City of Dilworth
Dilworth Community Center
Dilworth, MN

Project No. 25-011

ADDENDUM A

2 MECHANICAL MEZZANINE PLAN
SCALE: 1/8" = 1'-0"

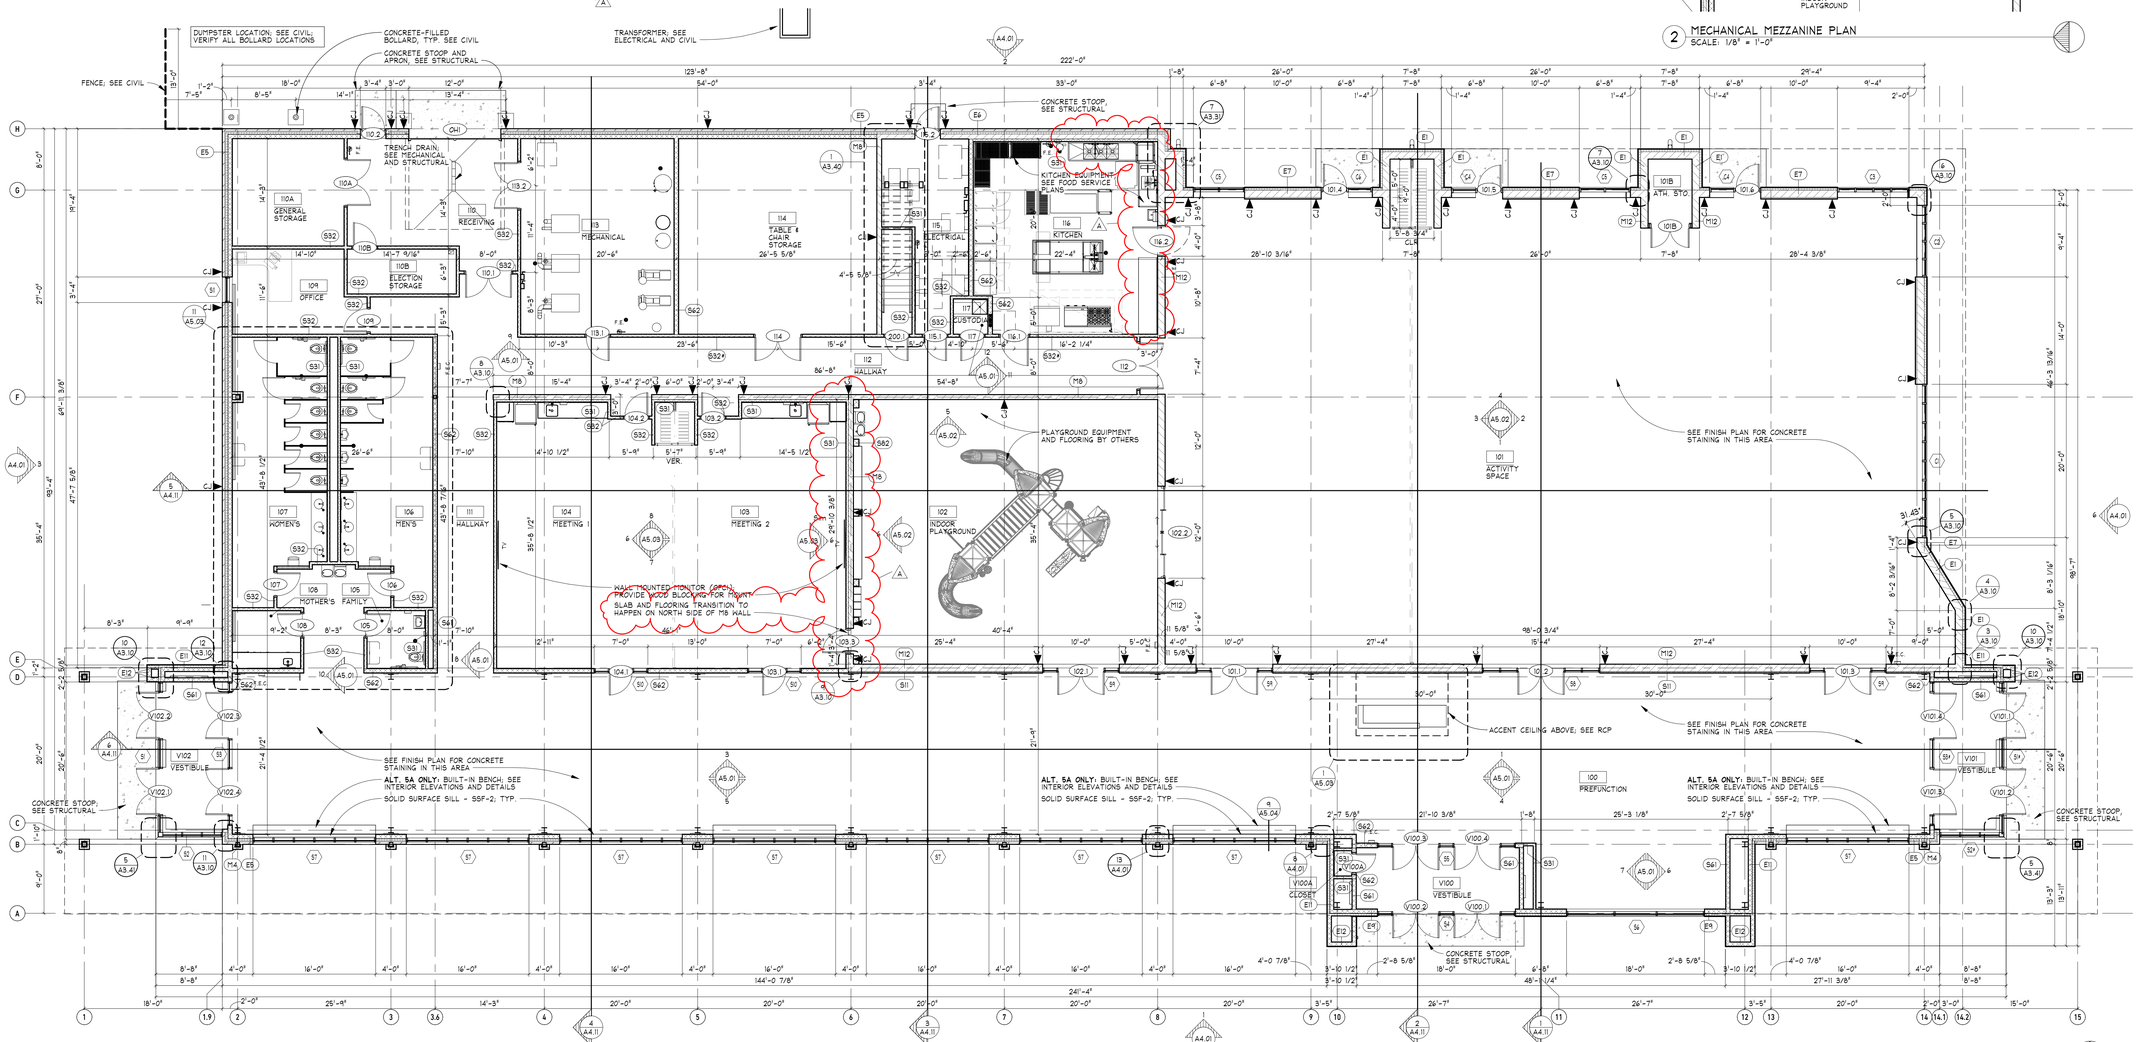
C. A3.10 Main Level and Mezzanine Plan – **Included in this addendum**
   a. View 1: Main Level Plan
      i. Shift food service equipment plan-east to be against M12 wall.
      ii. Add door 103.3 between 102 Indoor Playground and 103 Meeting 2.
      iii. Revise millwork and S82 wall in 102 Indoor Playground.
      iv. Add note: Slab and flooring transition to happen on north side of M8 wall.
   b. View 9: CMU Corner @ Steel Stud Corner
      i. Reflect changes associated with adding door 103.3.
      ii. Reflect changes of S82 wall and millwork in 102 Indoor Playground.
      iii. Add sound insulation in S31 wall in 103 Meeting 2.

2 MECHANICAL MEZZANINE FINISH PLAN
SCALE: 1/8" = 1'-0"

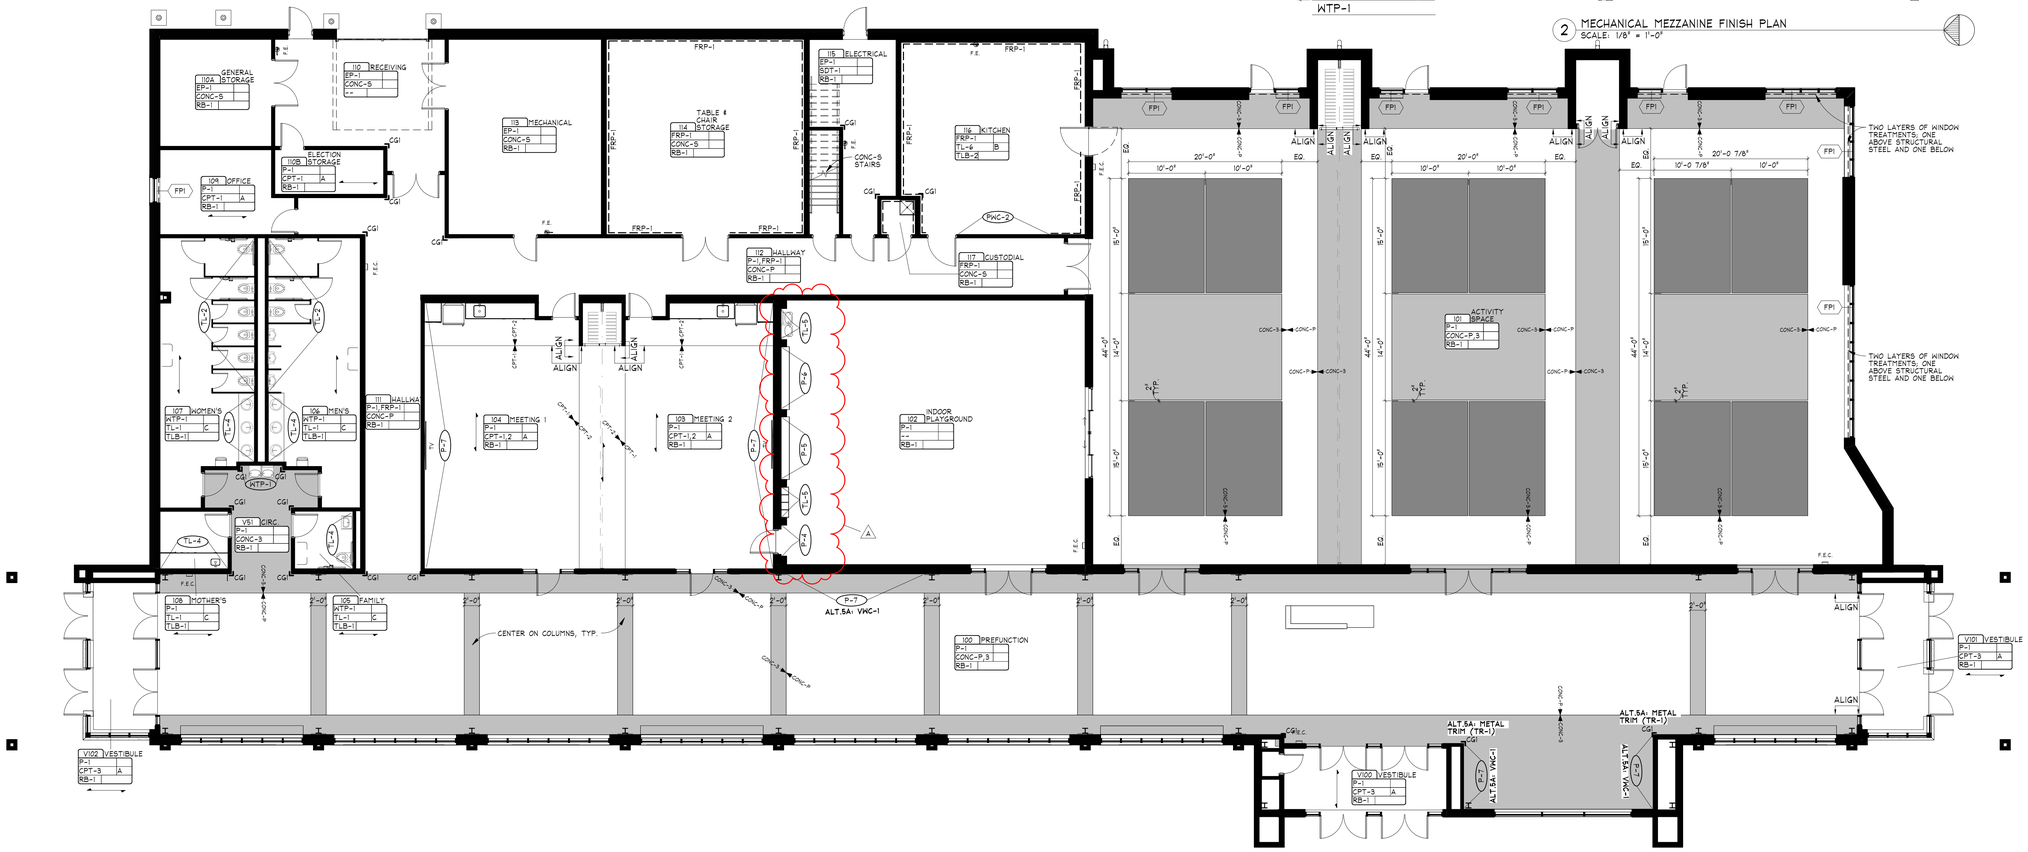
D. A3.31 Main Level Finish Plans – **Included in this addendum**
   a. View 1: Main Floor Finish Plan
      i. Remove notes in 102 Indoor Playground referencing any base and alternate bid items.
      ii. Revise finishes associated with the changes to the S82 wall and the addition of the door 103.3.
   b. View 7: CMU Exterior Wall Chase

ROOF PLAN

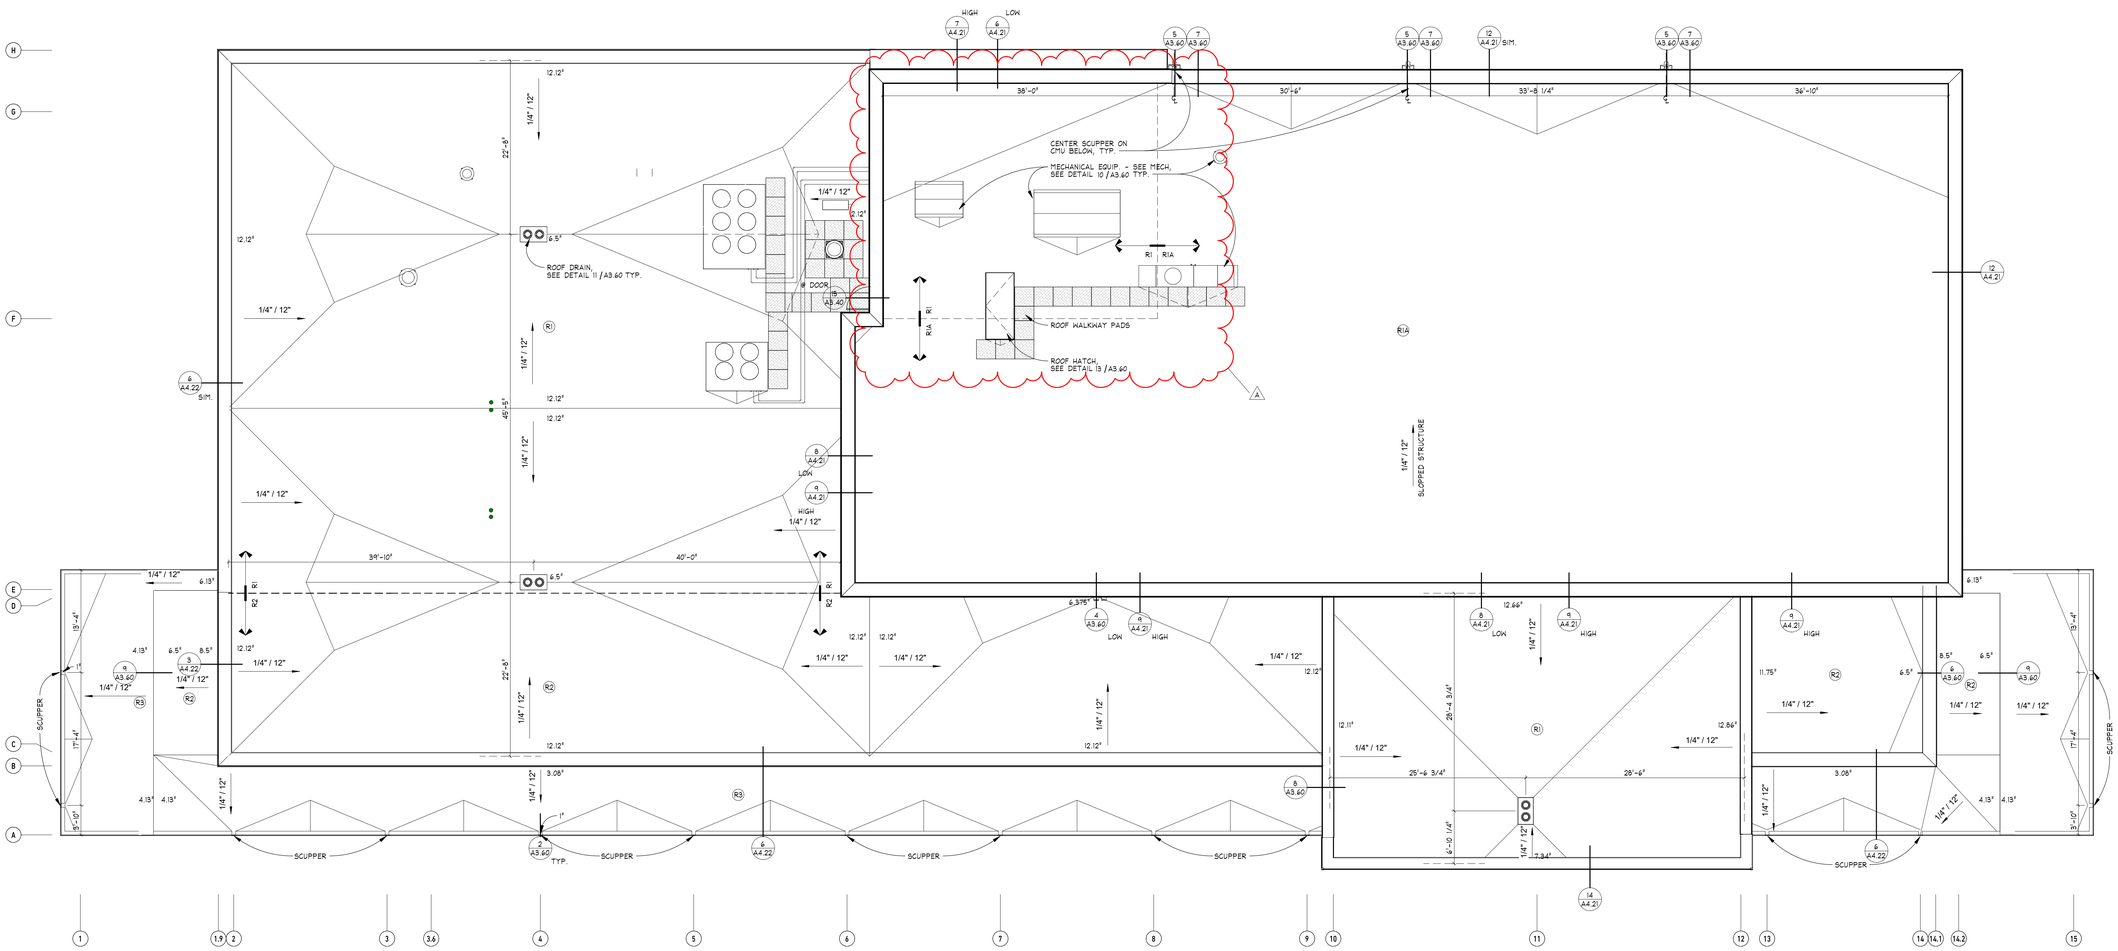
G. A3.60 Roof Plan – **Included in this addendum**
    a. View 1: Roof Plan
        i. Add delineation line and notes for acoustic deck and standard deck on high roof area.
    b. View 5 and View 7
        i. Add acoustic insulation in deck flutes.

3 BUILDING SECTION - PREFUNCTION & MEZZANINE
SCALE: 1/8" = 1'-0"

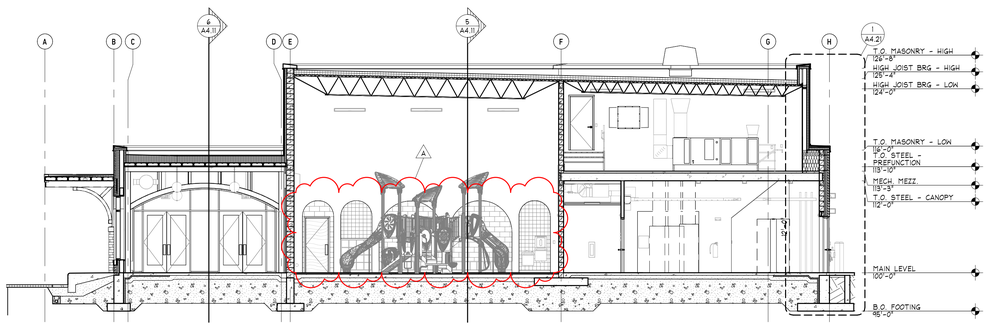
H. A4.11 Building Sections – **Included in this addendum**
    a. View 3: Building Section – Prefunction & Mezzanine
        i. Reflect changes associated with adding door 103.3
        ii. Reflect changes of S82 wall and millwork in 102 Indoor Playground

6 102 INDOOR PLAYGROUND - NORTH
SCALE: 1/4" = 1'-0"

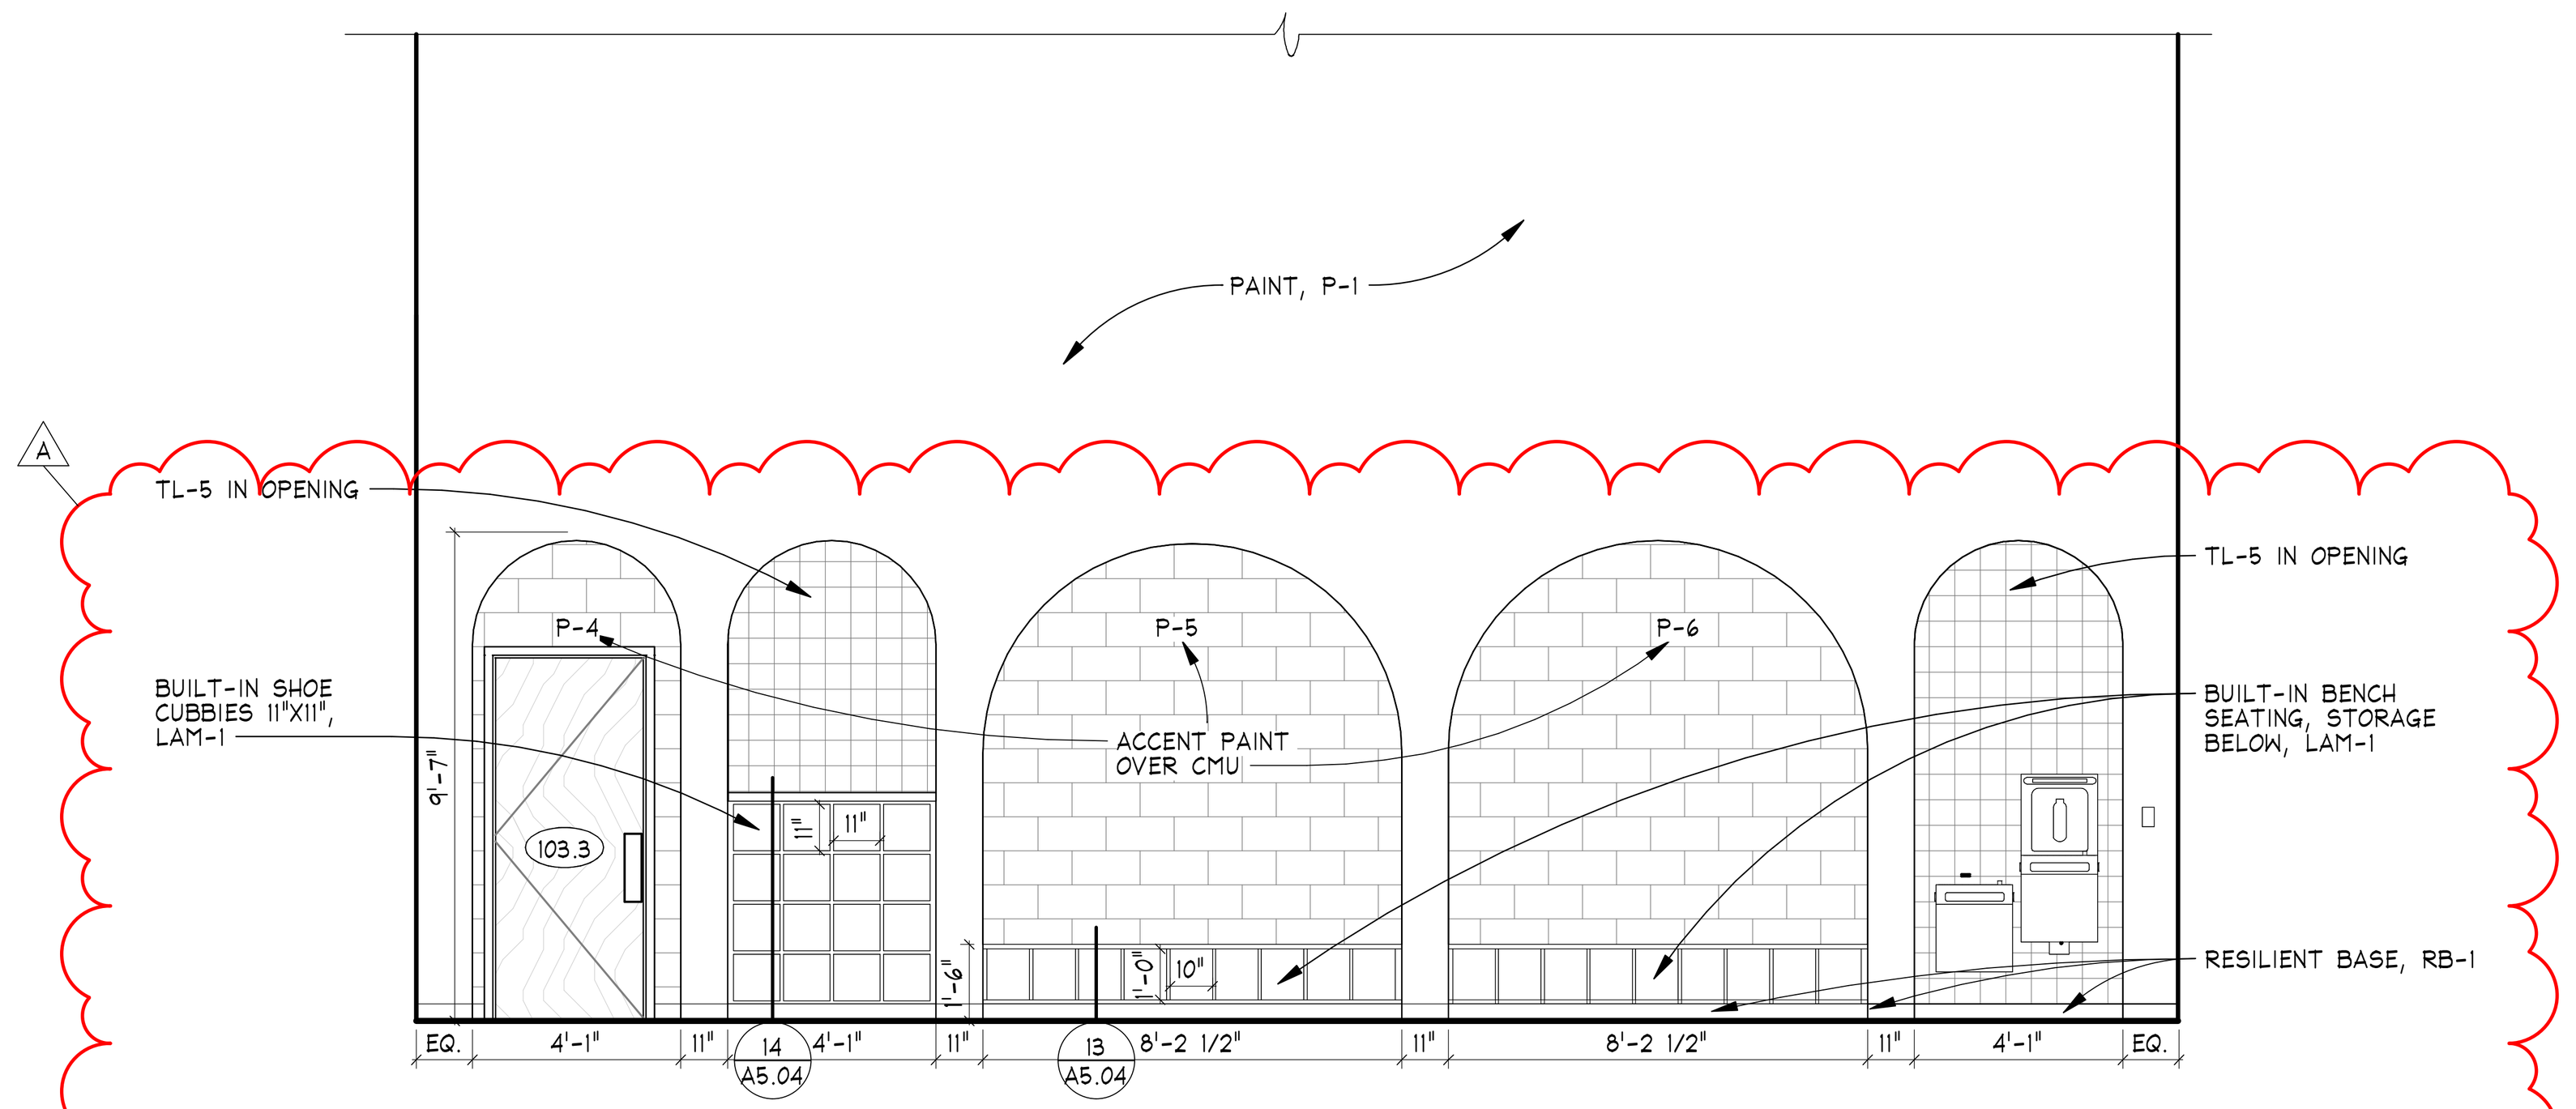
K. A5.02 Interior Elevations – **Included in this addendum**
    a. View 6: 102 Indoor Playground – North
        i. Reflect changes associated with adding door 103.3.
        ii. Reflect changes of S82 wall and millwork in 102 Indoor Playground.
        iii. Reflect changes of wall finishes in 102 Indoor Playground.
